Arlington County Department of
Environmental Services
DES

**Construction Standard Details
2020**

**Update #1
February 2023**

The following Standard Details are modified or added to the 2020 DES Construction Standard Details:

ISSUED	9/14/2020
DRAWING NO.	
M-3.0

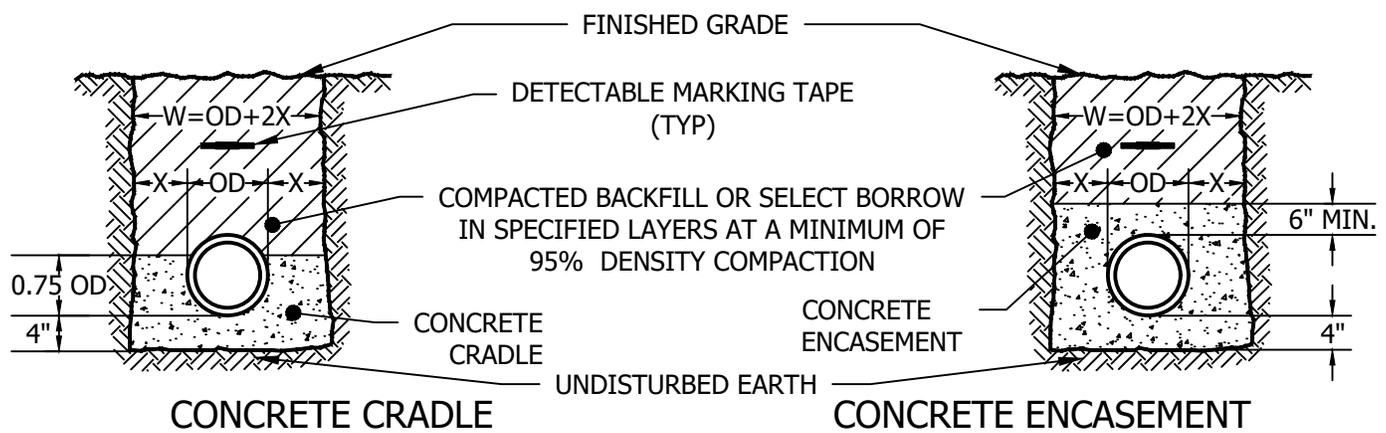
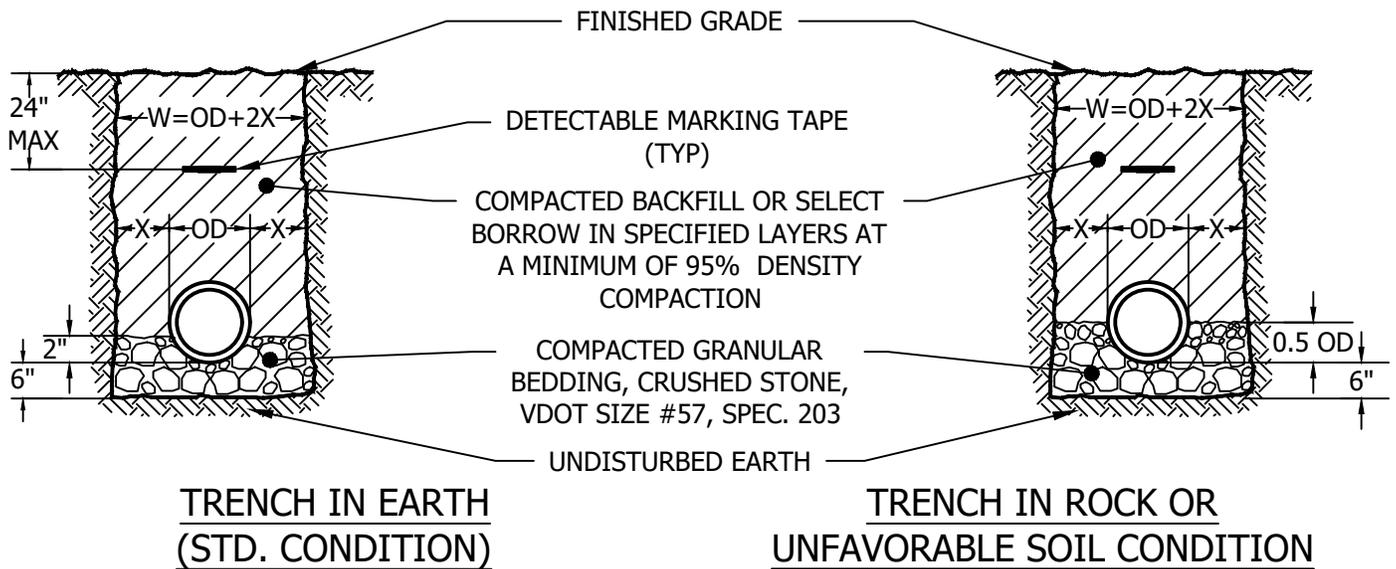
Detail M-3.0 Pipe Bedding Details for Trench Conditions [*Modification*]

- Added Detectible Marking Tape

DRAWING NO.
M-9.0

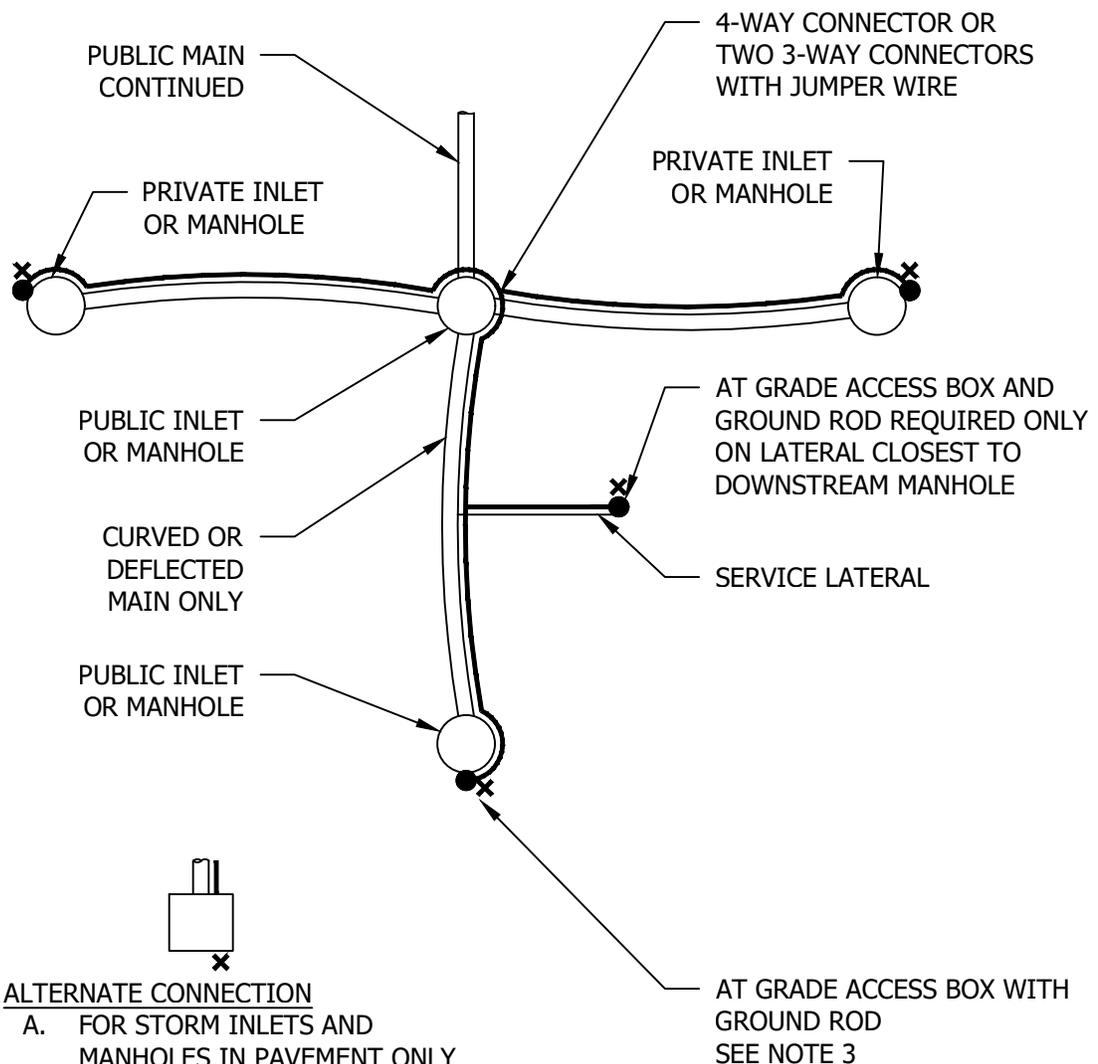
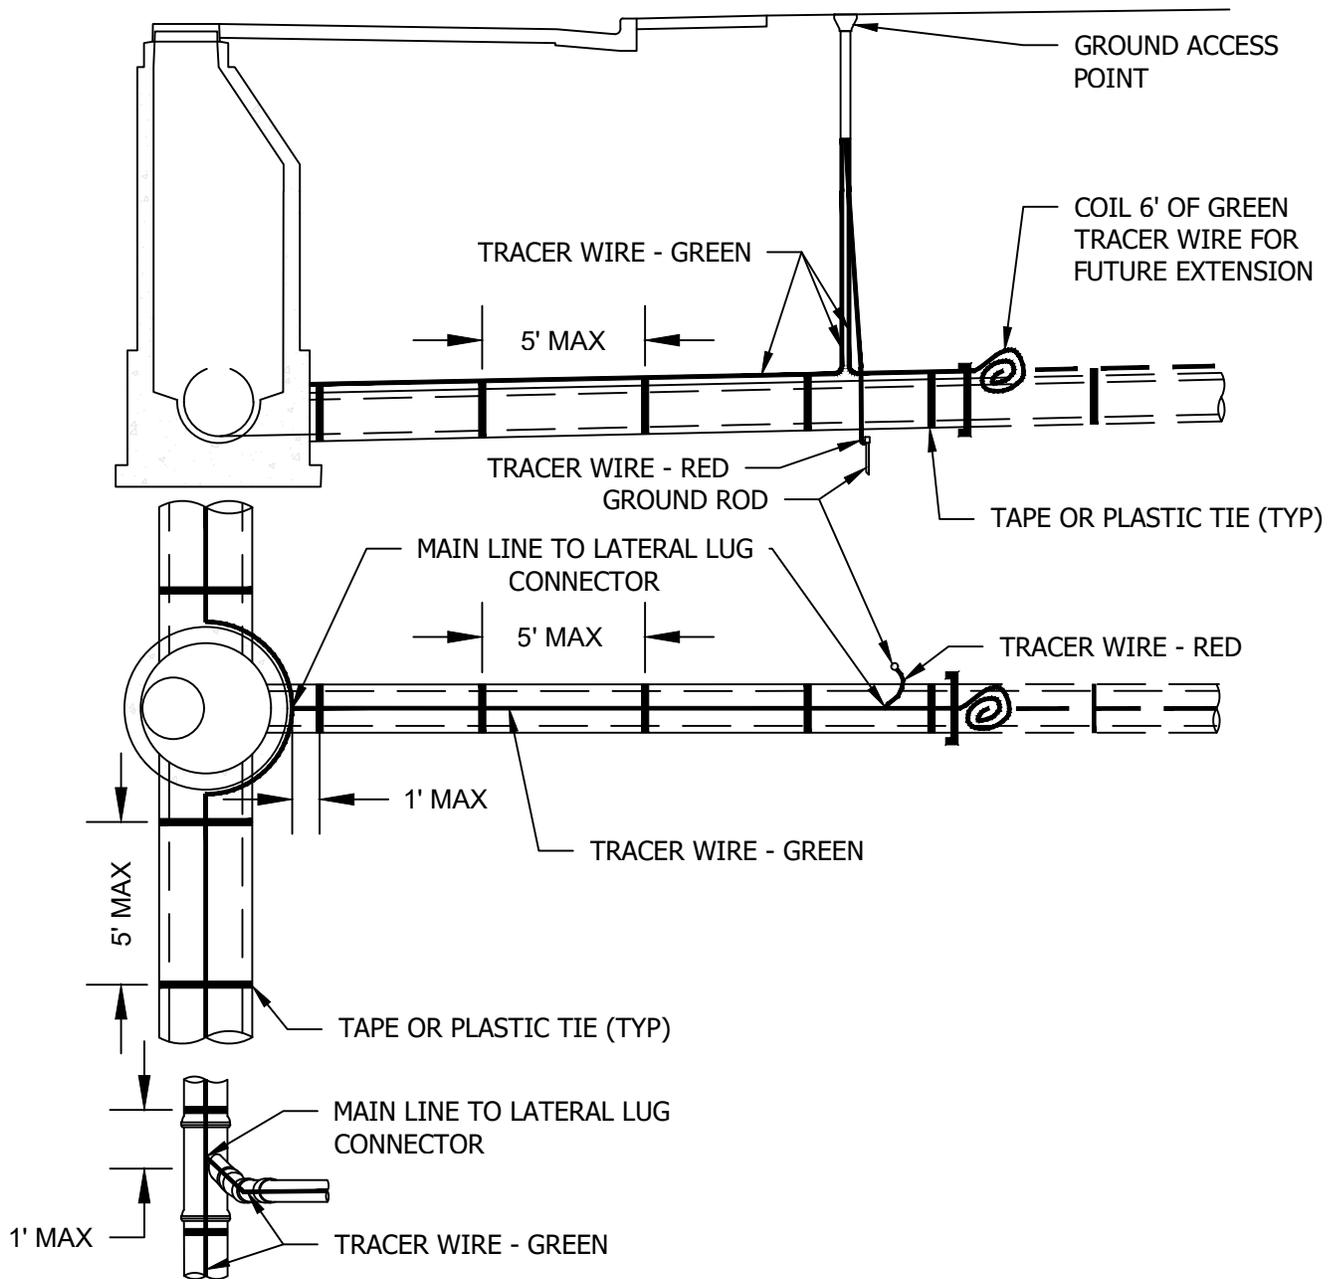
Detail M-9.0 Tracer Wire Sample Plan [*New Detail*]

- New Detail

DRAWING NO.
M-9.1

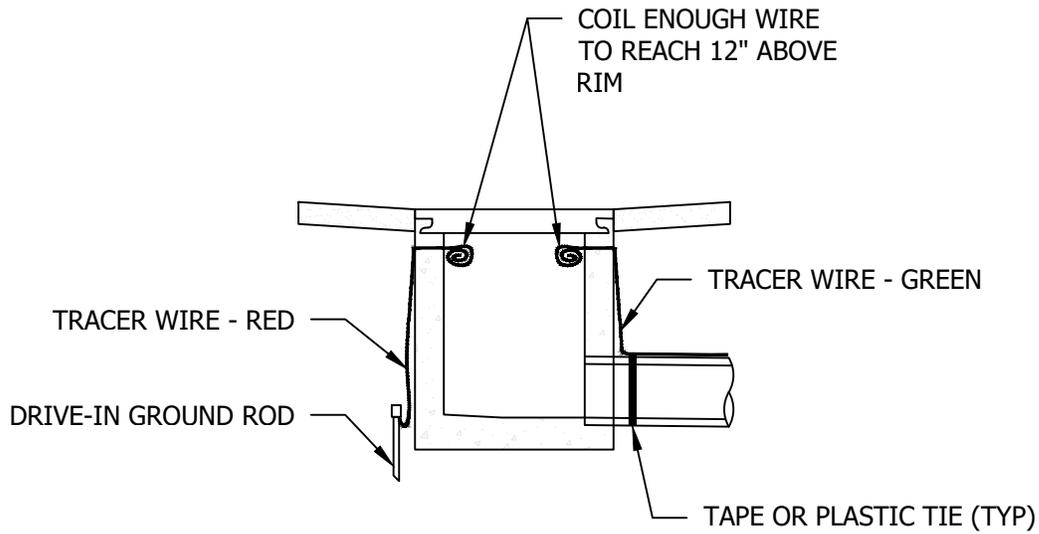
Detail M-9.1 Tracer Wire Lateral Detail [*New Detail*]

- New Detail

1	2/28/2023
ISSUED	9/14/2020
DRAWING NO. R-2.4A

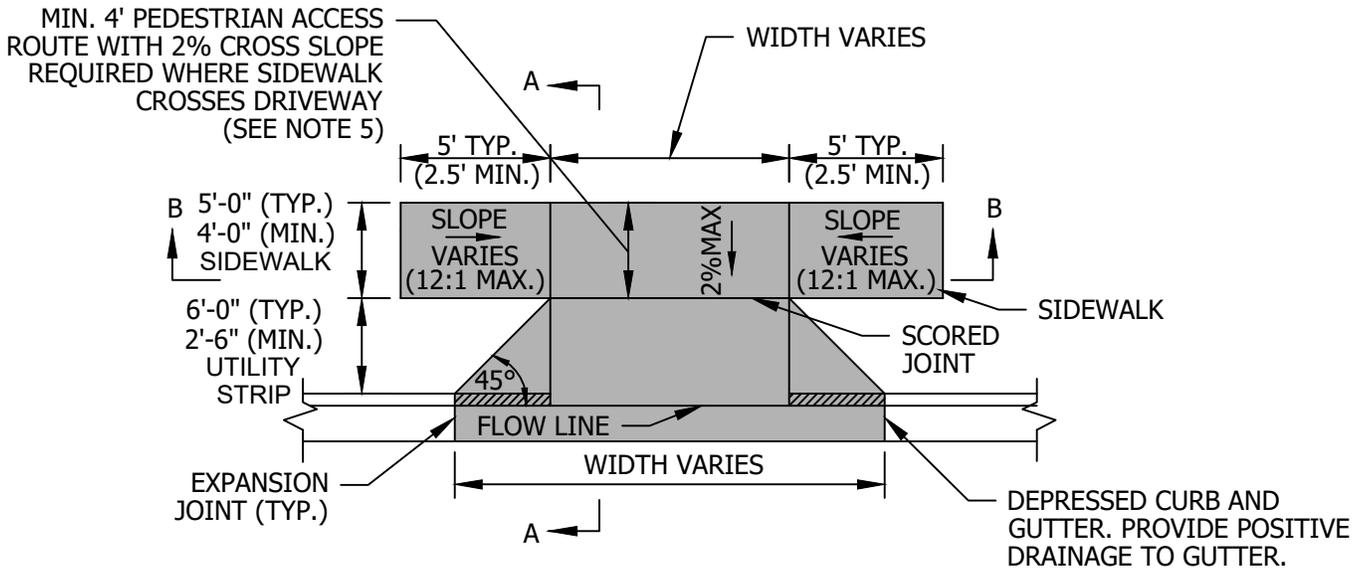
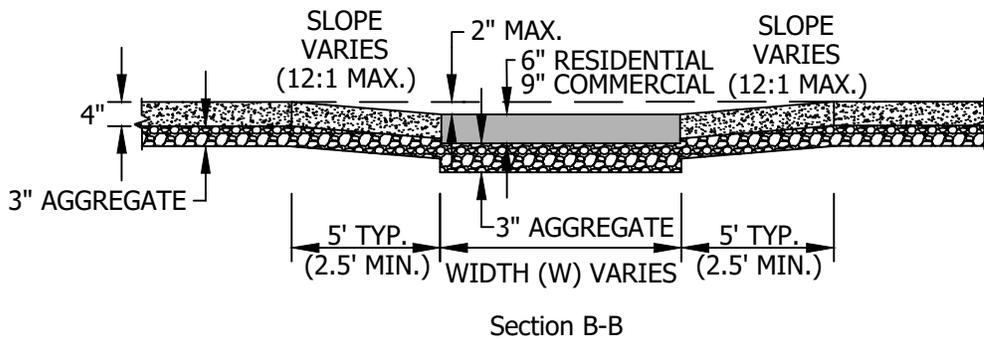
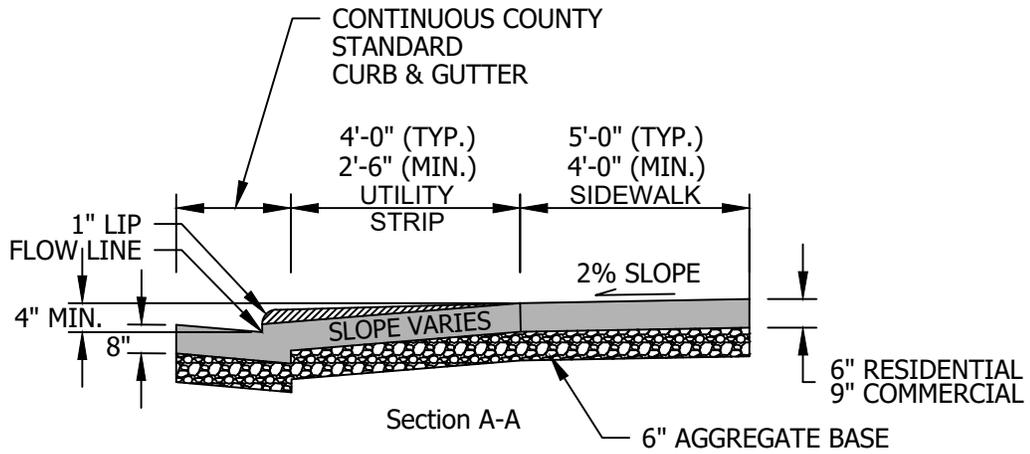
Detail R-2.4A Concrete Driveway Entrance [*Modification*]

- Removed Reference to R-2.4A Sheet 2
- Revised Typical Width of Utility Strip to 6’0”

DRAWING NO.
R-2.4B
SHEET 1 OF 2

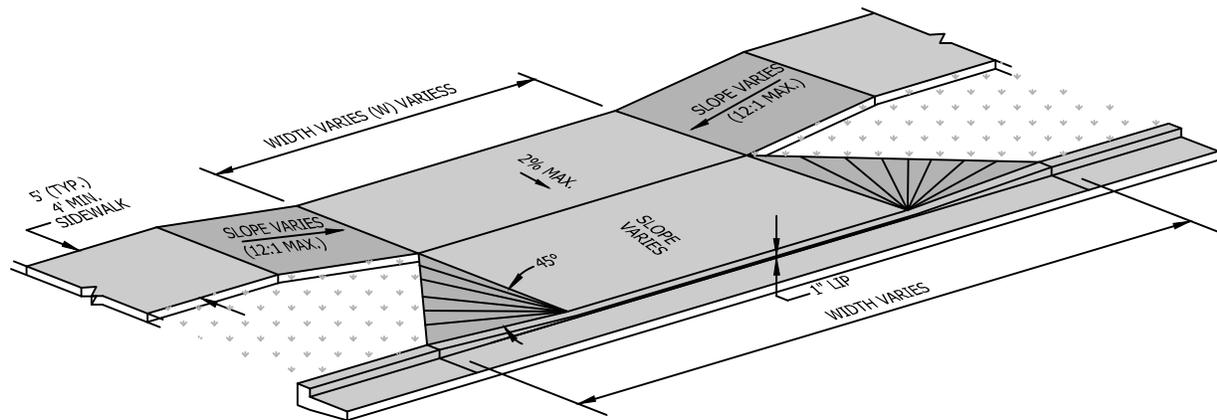
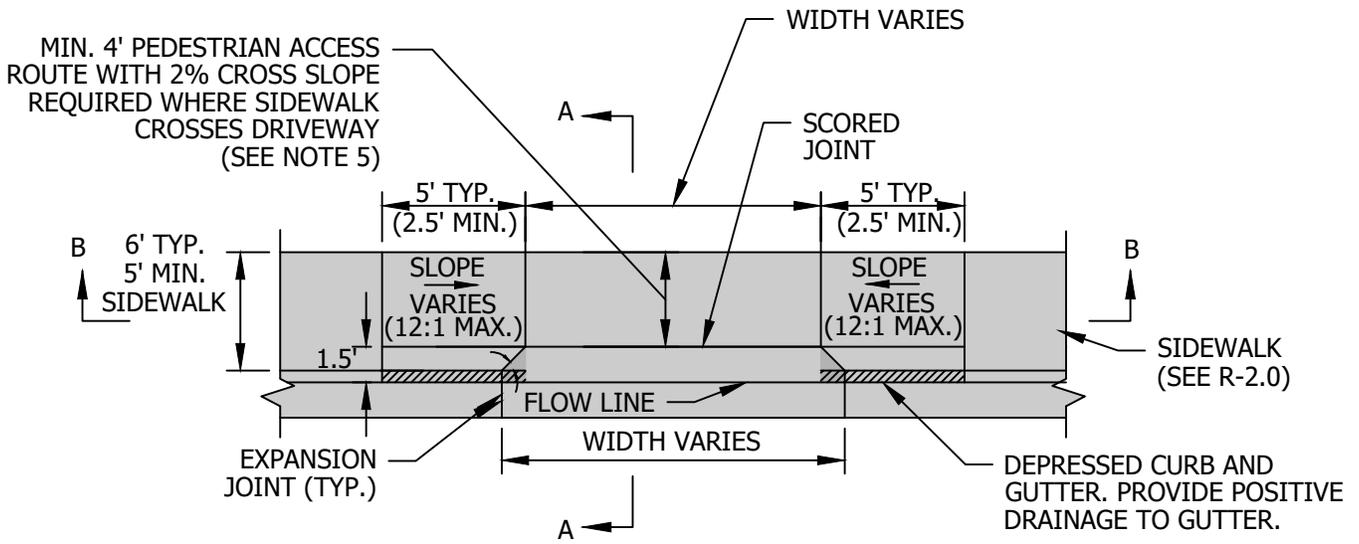
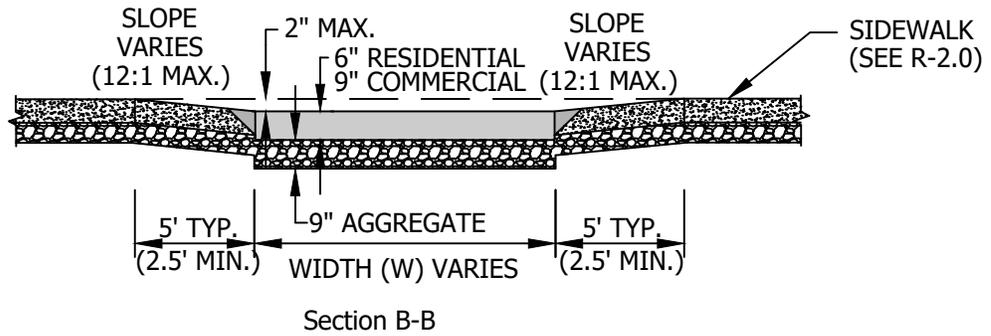
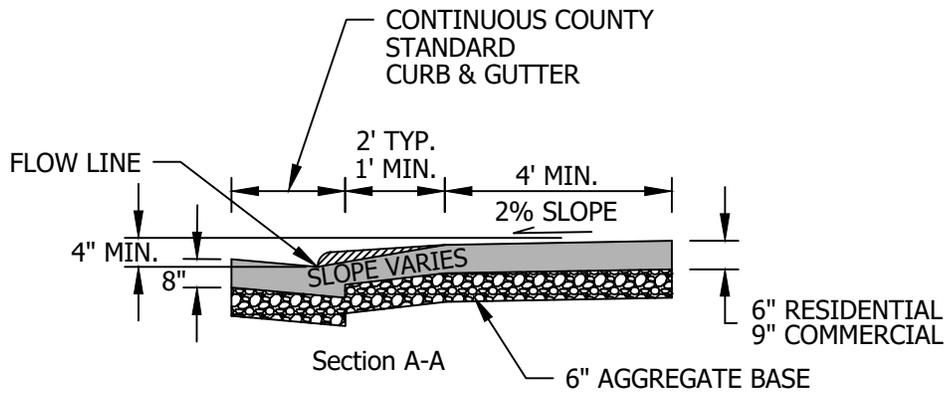
Detail R-2.4B Concrete Driveway Entrance (Depressed) [*Modification*]

- Removed Reference to R-2.4A Sheet 2
- Revised Typical Utility Strip Width to 6’0”

1	10/7/2021
ISSUED	9/14/2020
DRAWING NO.	
R-2.4C	
SHEET 1 OF 2

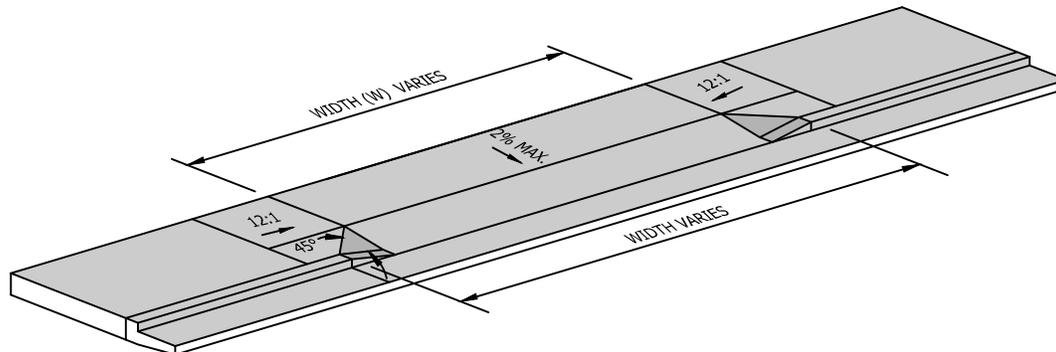
Detail R-2.4C Concrete Driveway Entrance (Mountable Curb) [*Modification*]

- Removed Reference to R-2.4A Sheet 2
- Revised Typical Sidewalk Width to 6’
